TSB150068

Fault Code 2722 Due to Low Pressure Regulator Housing Casting Defect

Figure 2, Low Pressure Regulator Bore with Pitting

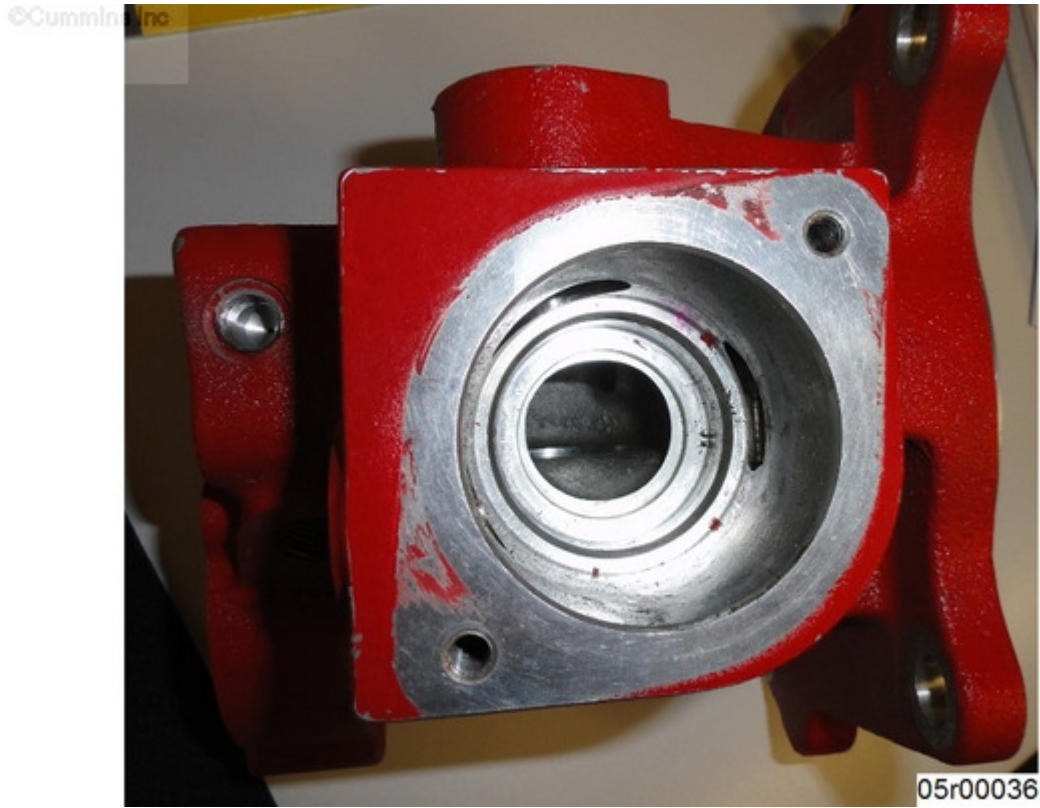
Inspect the low pressure regulator bore in the low pressure regulator housing for signs of

pitting. The pitting may appear to be dirt or debris, but can **not** be cleaned from the low pressure regulator bore. See Figures 2 through 4.

If pitting is found, replace the low pressure regulator housing. Use the following procedure in the ISX12 G CM2180 EJ Service Manual, Bulletin 4310682. [Refer to Procedure 005-238 in Section 5.](#)

Figure 5, Low Pressure Regulator Date Code

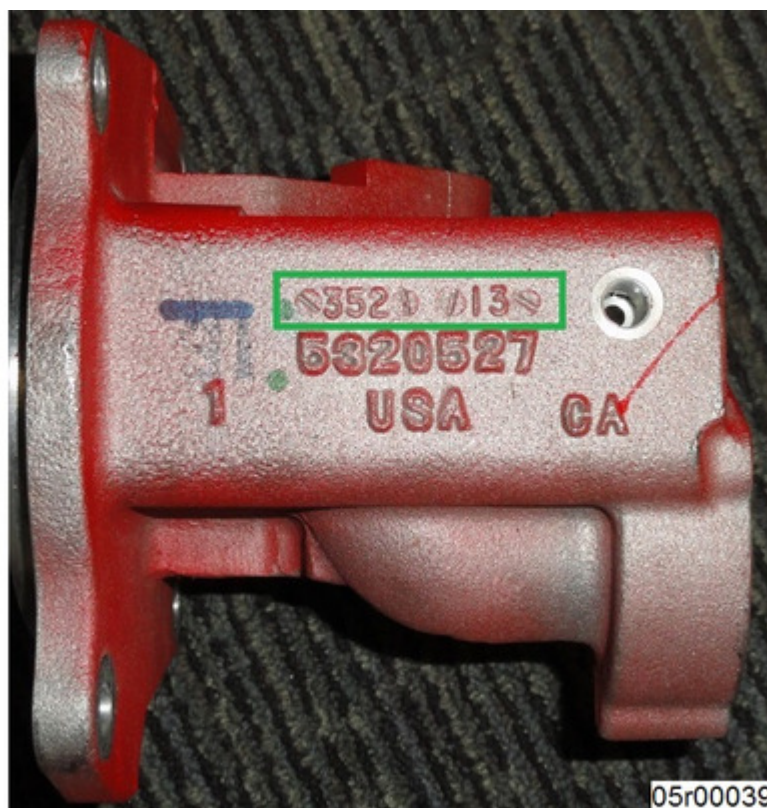
Revisions to the low pressure regulator casting were implemented on 07 April 2014. Revision changes include adding material to the low pressure regulator casting prior to machining. Suspect low pressure regulator casting dates are prior to 097 14. Date code format is DDD YY. 097 14 is equivalent to the 97th day in 2014. See Figure 5.
